# MOTOROLA

## MC68306

### ADDENDUM TO MC68306 Integrated EC000 Processor User's Manual

September 8, 1995

Figure 8-1. Drive Levels and Test Points for AC Specifications

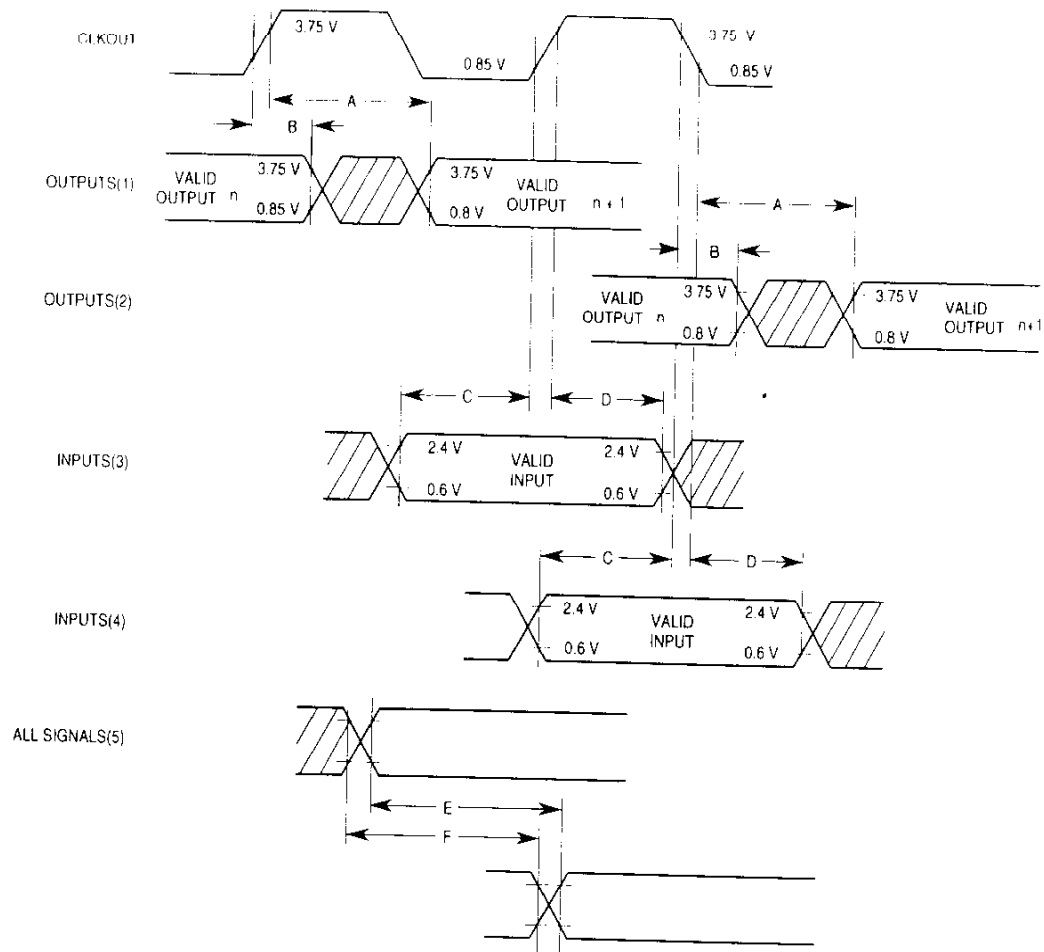
The current drive levels and test points for the MC68306 are shown in the revised Figure 8-1 below (page 8-3).

Figure 8-5. Chip Select and Interrupt Acknowledge Timing Diagram

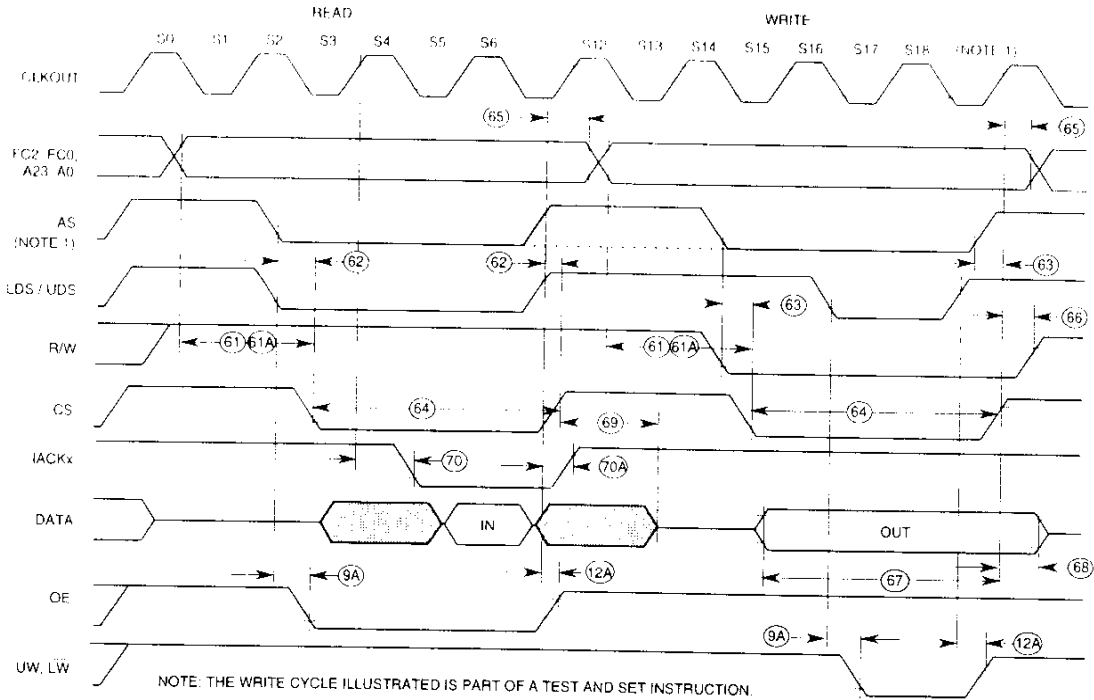
IACKx is shown asserted too early in Figure 8-5 on page 8-9. The figure below shows IACKx assertion time (spec 70) correctly referenced to the rising edge of state S4.

Figure 8-2. Clock Output Timing

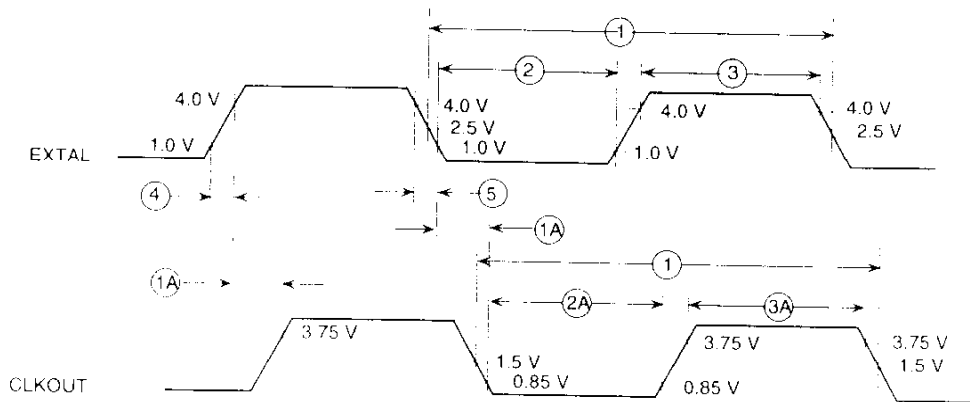
The current drive levels and test points for the MC68306 input and output clocks are shown in the revised Figure 8-2 below (see page 8-5.)

Figure 8-8. DRAM Timing – 0-Wait Read, No Refresh

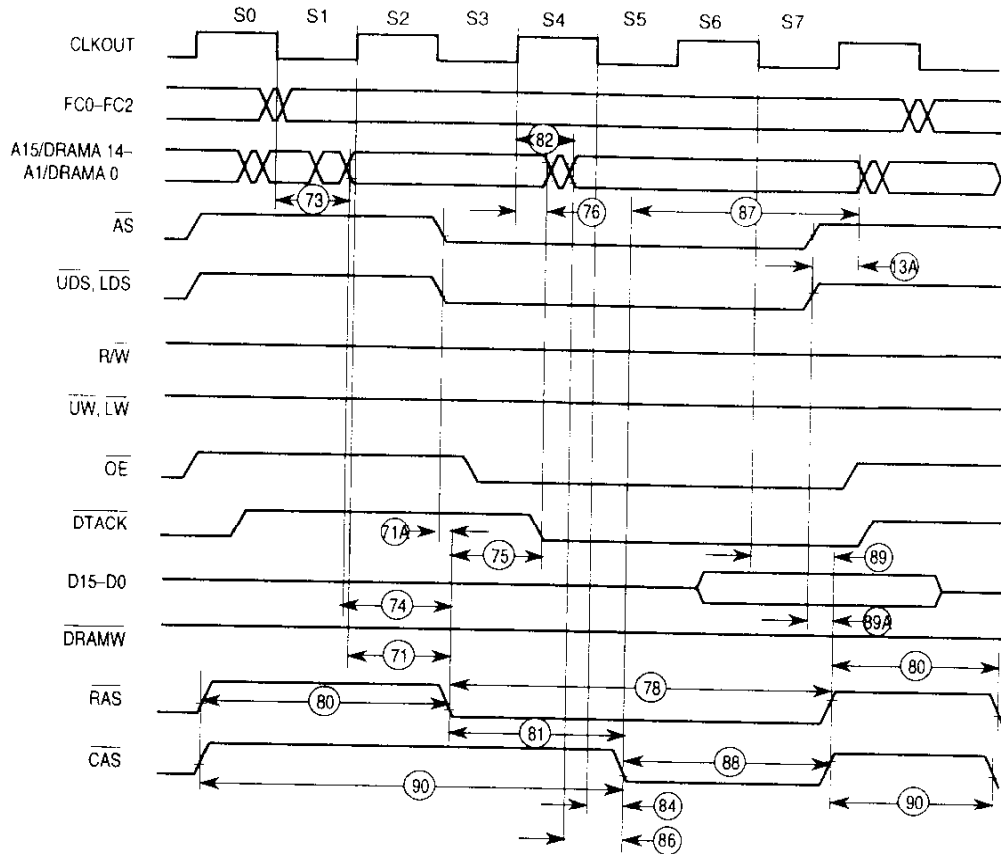
Specification 13A below has been added to the AC electrical specifications on page 8-5. A revised figure 8-8 from page 8-13 shows the new specification (address hold from  $\overline{AS}/\overline{UDS}/\overline{LDS}$  negate near state S7).

Num	Characteristic	16.67 MHz		Unit
		Min	Max	
13A	$\overline{AS}$ , $\overline{LDS}$ , $\overline{UDS}$ Negated to Address Invalid, DRAM Cycle	0	—	ns

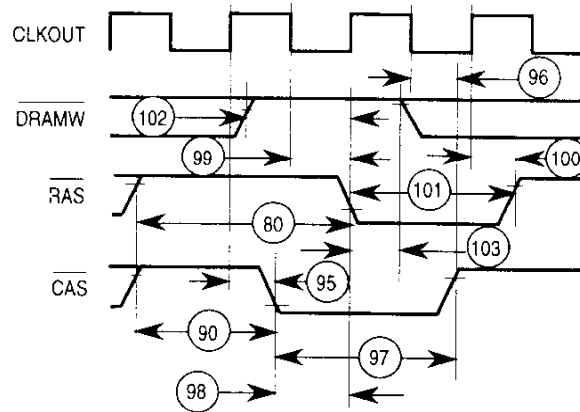
In paragraph 5.2.6.2 on page 5-10, the reset value of CS0 bit 15 (CSR-Chip Select Read enable) is one, not zero.

Figure 8-10. DRAM Timing Refresh

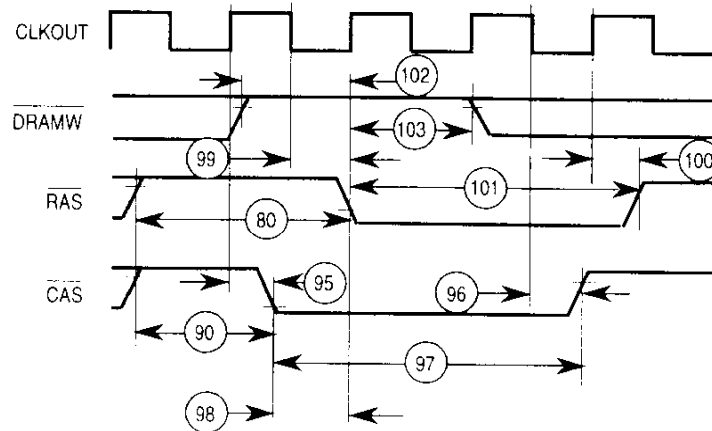
The specifications for DRAM refresh timing in the AC Specifications on page 8-12 and in Figure 8-10 on page 8-14 referenced the wrong clock edges. Corrected specifications and figures are shown below.

Num.	Characteristic	16.67 MHz				Unit
		0-Wait		1-Wait		
		Min	Max	Min	Max	
95	CLKOUT High to CASx Asserted (Refresh Cycle)	0	20	0	20	ns
96	CLKOUT Low to CASx Negated (Refresh Cycle)	0	20	0	20	ns
98	CASx Asserted to RASx Asserted (Refresh Cycle)	20	60	20	60	ns
99	CLKOUT Low to RASx Asserted (Refresh Cycle)	0	30	0	30	ns
100	CLKOUT High to RASx Negated (Refresh Cycle)	0	25	0	25	ns
102	DRAMW High to RASx Asserted (Refresh Cycle)	20	60	20	60	ns

Figure 8-9. DRAM Timing – 1-Wait Write, No Refresh

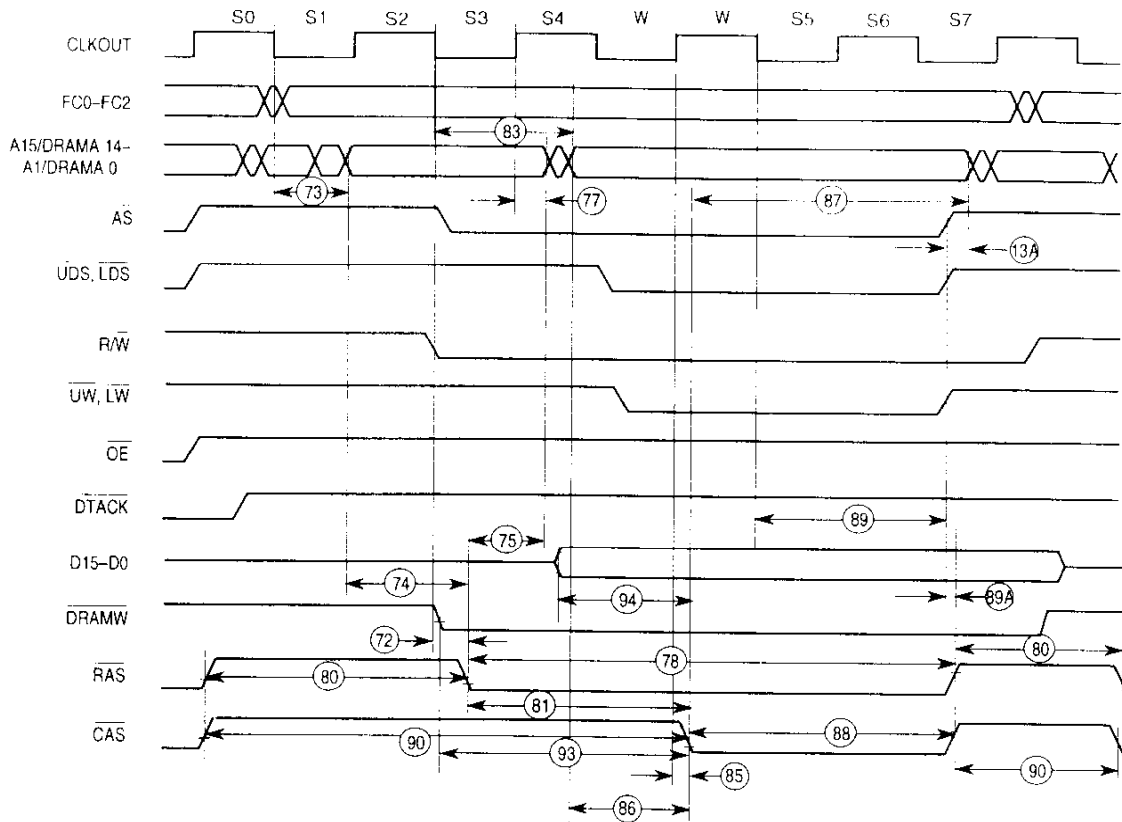
Figure 8-9 on page 8-14 is missing a wait state - see the revised figure below. Spec: 13A has also been added to this figure.

CASE 831A-02  
ISSUE B

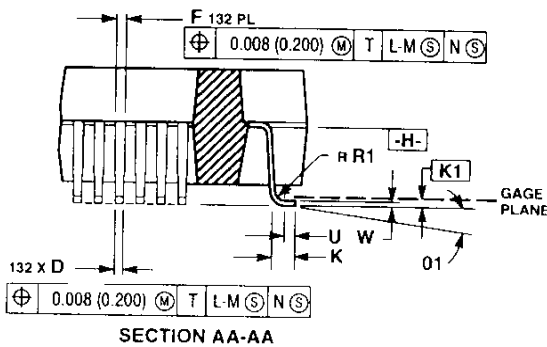
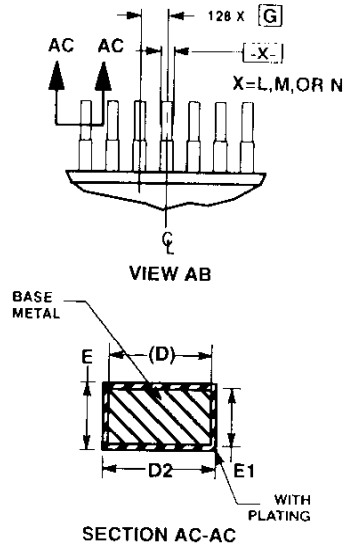
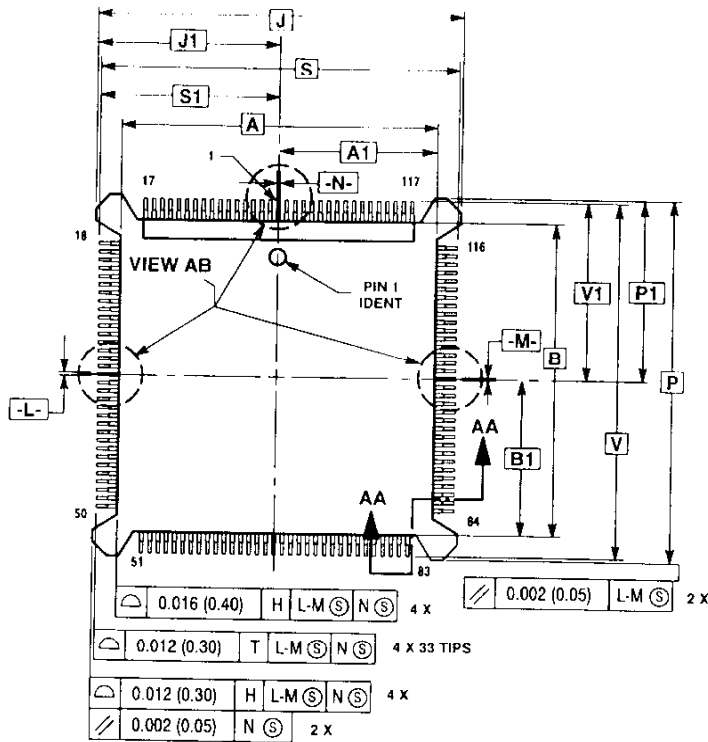
The 132-pin package diagram on page 9-4 shows 32 pins on a side. There are actually 33 pins on a side. The specifications for the case size and pin spacing are correct.
